VANDERBURGH COUNTY ENGINEERING DEPARTMENT

RE: Camden Farms Subdivision

As was requested, an inspection has been completed in Camden Farms subdivision. Based on this inspection and previous items on the punch list dated June 27, 2008, the following remains to be addressed:

RE: Windemere Farms Sections 1-4, Camden Farms, Oaklynn Park, Ashton Park

CONCRETE DITCH LINER DETAIL

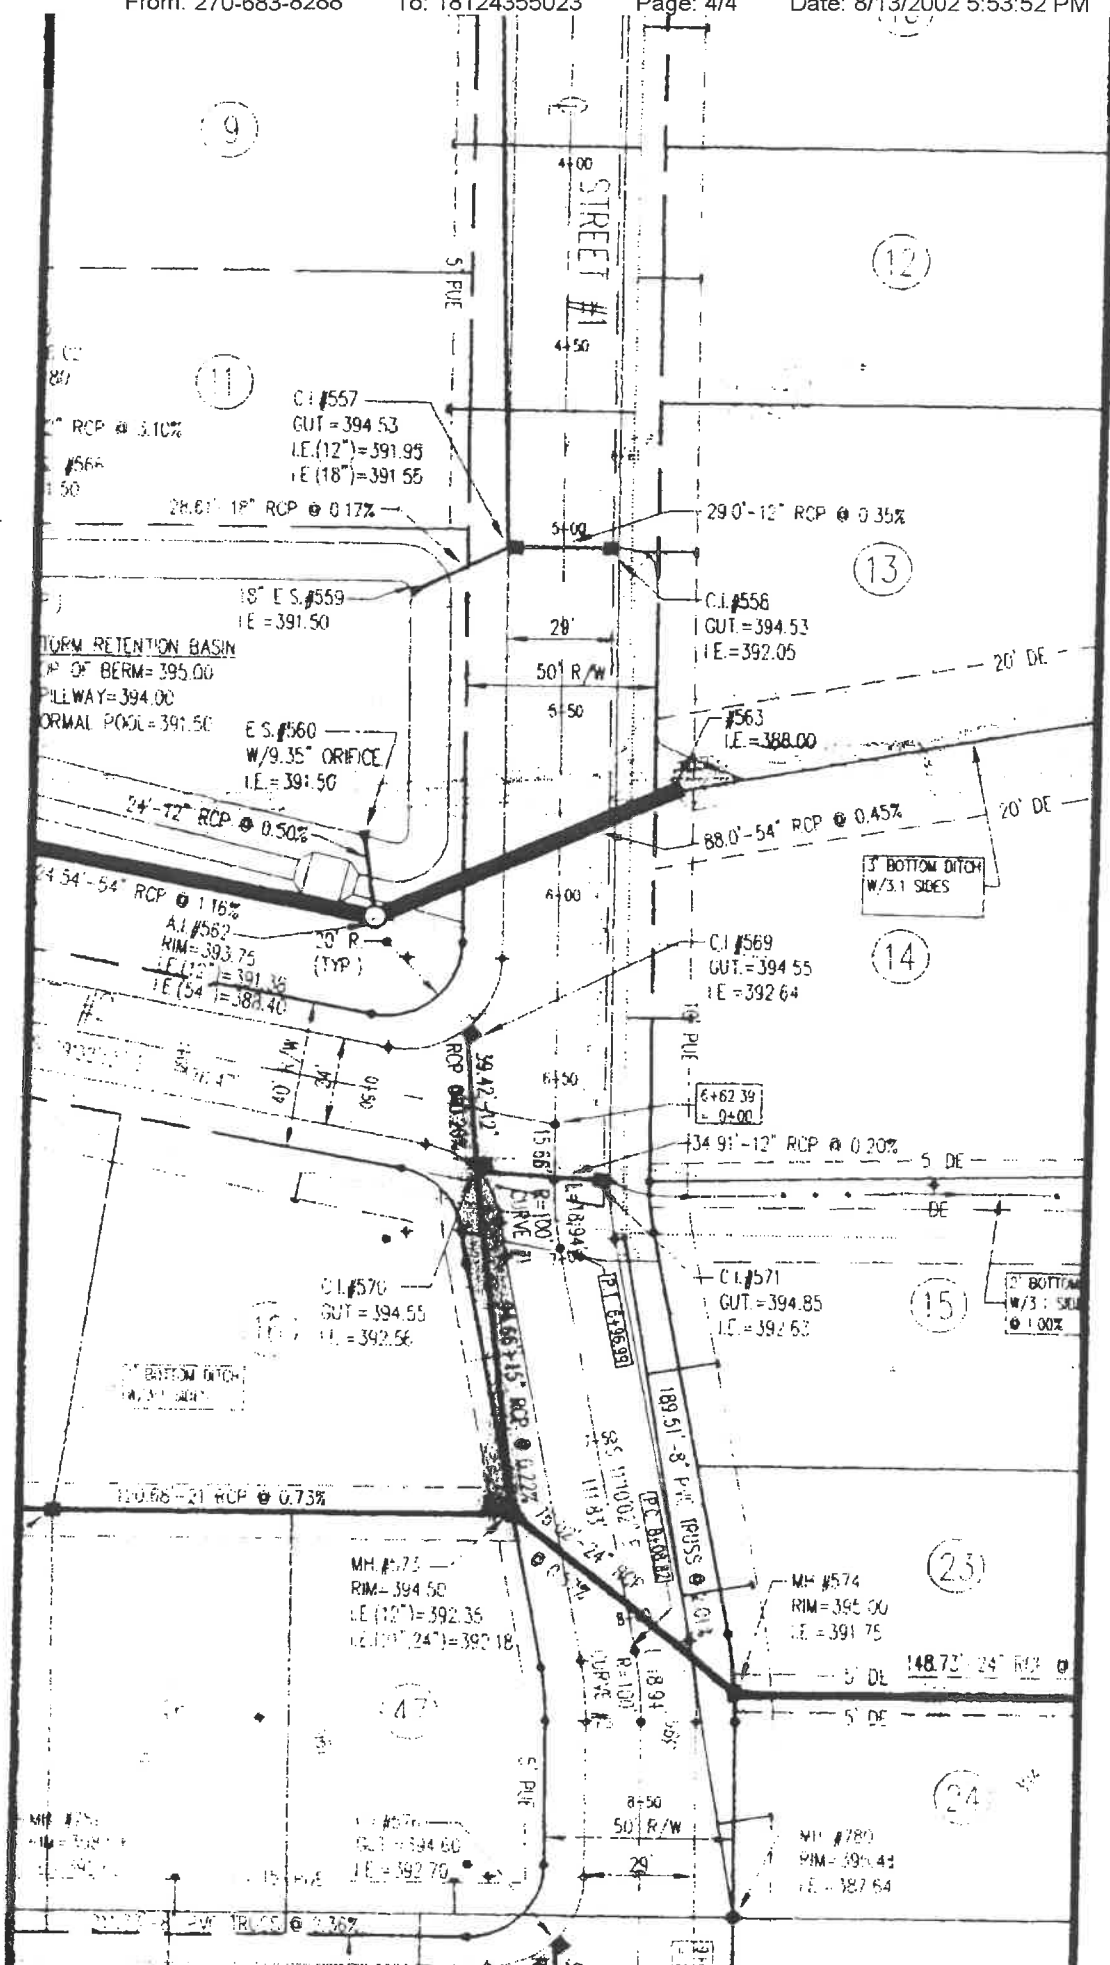
Attached is a detail for the concrete ditch liner that I discussed with you this past Friday, August 9, 2002. Jagoe Homes, Inc. plans to install the concrete liner in the existing drainage ditch bottom from the east end of the existing 54" RCP installed by the developer of Camden Farms and extending easterly for a distance of approximately 15'. The liner will prevent silt and water from collecting at the end of the drainage pipe that has been a nuisance for the owner of Lot 14.

It is requested that the concrete ditch liner detail be approved for the 15' section of ditch in Camden Farms, described above and as shown on the attachments, at your earliest convenience.
